## Rose Red Quarry M-2013-068

**RE: Colorado Rose Red Stone Resource, M-2013-068, AM-02 Adequacy Response 5**

**Adequacy Review No. 1 – Items identified in the DRMS letter dated January 8, 2018.**

**Figure 1.** Schematic cross-section of the surface quarry operation at the Colorado Rose Red Quarry.

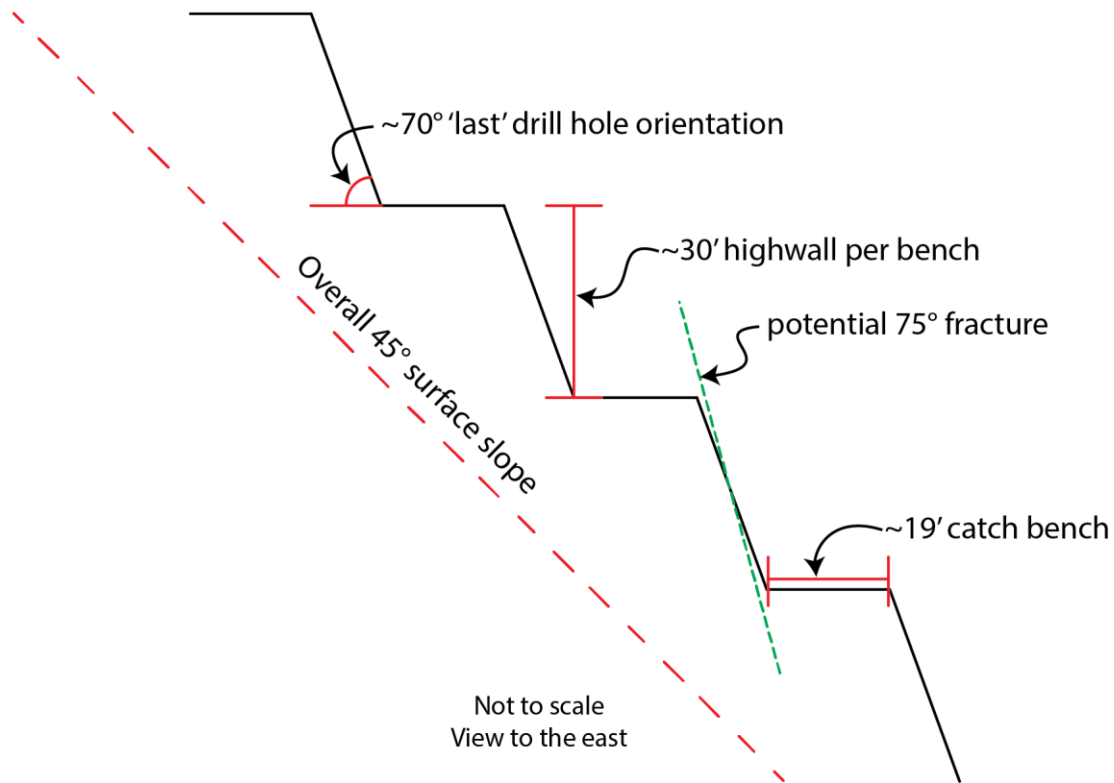
- d. **DRMS Response 5:** DRMS is concerned about the potential for a massive block failure in the surface quarry. Table 1 in the analysis submitted indicates there is a principle joint set striking essentially east-west through the site with a dip angle  $75^{\circ}$  to the south. Our understanding is the highwall in the quarry will generally trend east-west as well, with 30-foot near vertical intra-bench highwalls. If this principle joint set were to daylight new the toe of one of the intra-bench highwalls, the potential for a massive block failure seems likely. Please provide a cross-section showing the local geologic structures and how the intra-bench highwalls will be designed and constructed to control and mitigate a massive block failure.

- e. **GLA Response 4/5:** To mitigate potential mass rock movement along the above detailed  $75^{\circ}$  south dipping fracture, the batter angle will be pushed to  $70^{\circ}$ , see the below Figure 1 cross-section. Any fractures within the pit wall cannot daylight and allow a massive block failure. The dashed green line represents a hypothetical  $75^{\circ}$  fracture – notice how rock mass above the intersection of the fracture and the face will be cleared as the final  $70^{\circ}$  batter angle is realized. Rock mass below the intersection of the fracture and the face will not experience movement as the rock mass will be contained in the catch bench. If the  $75^{\circ}$  fracture occurs along a catch bench, no failure will occur as the fracture will be constrained within the catch bench unable to daylight. By changing the batter angle to  $70^{\circ}$  the previously proposed 30 foot catch bench will now have a length of ~19 feet. This length will be more than adequate to account for mining equipment traffic. Additionally, best management practices will be utilized during every phase of surface excavation including but not limited to: highwall scaling, erection of safety berms, and potential closure of hazard areas until the hazard can be fully mitigated.
